Kitchen//Existing//Elevation 4_1:20

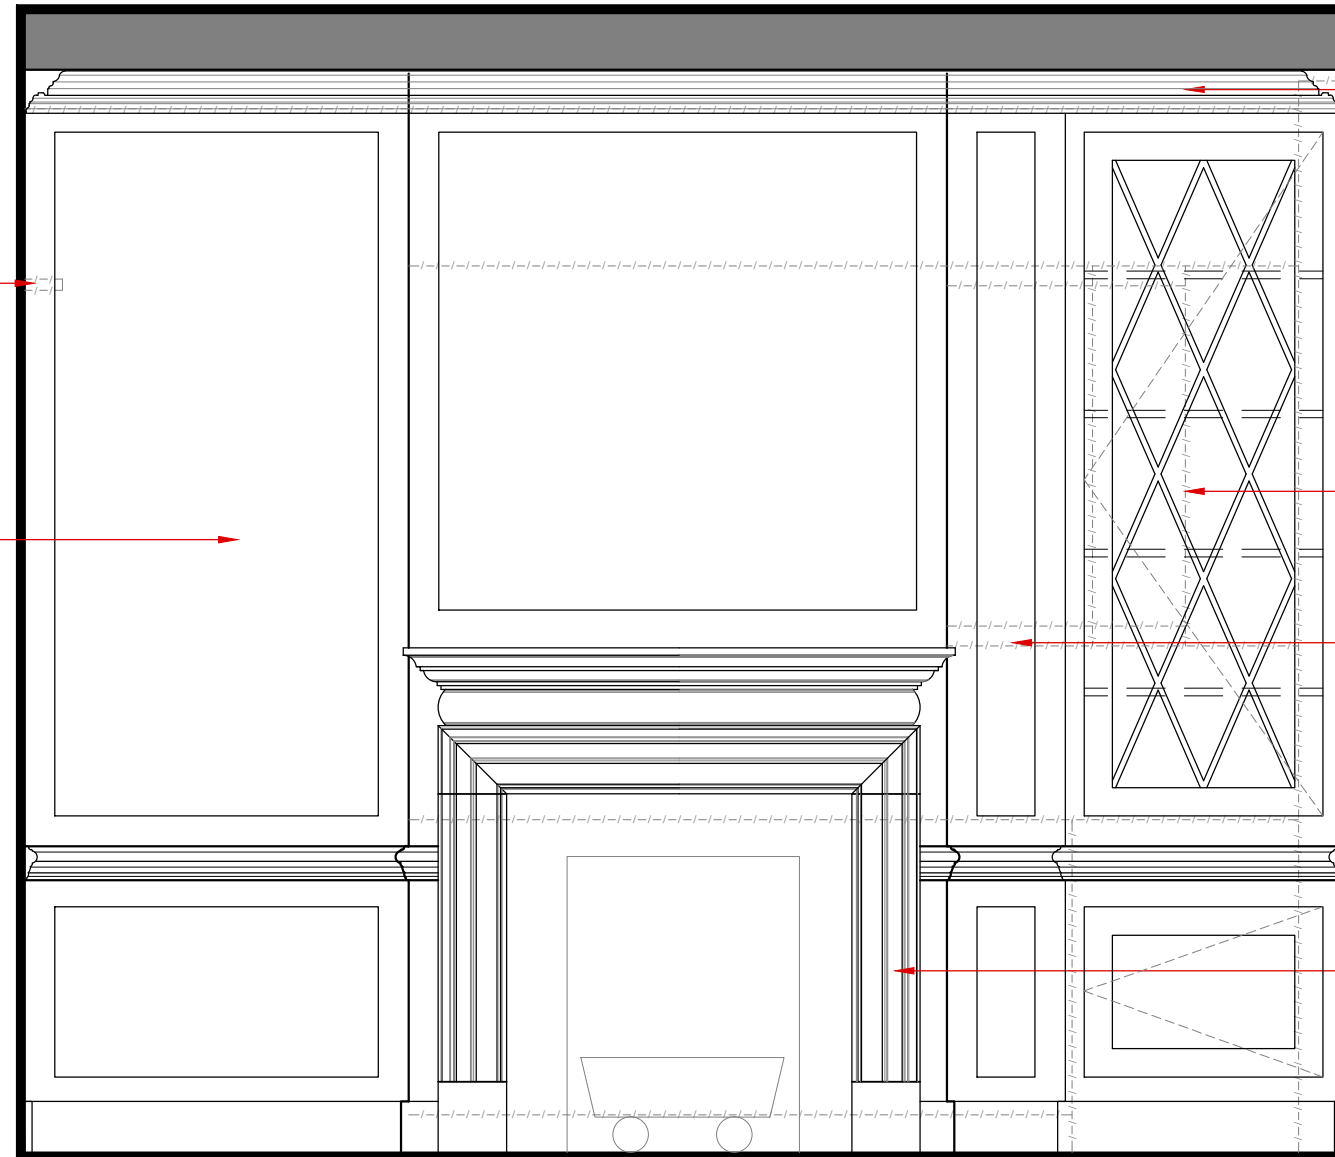
Rev	Date	Notes
A	14.05.15	Service duct stepped back following comments from council.

Proposed service run. Wall to be stepped back from chimney breast.
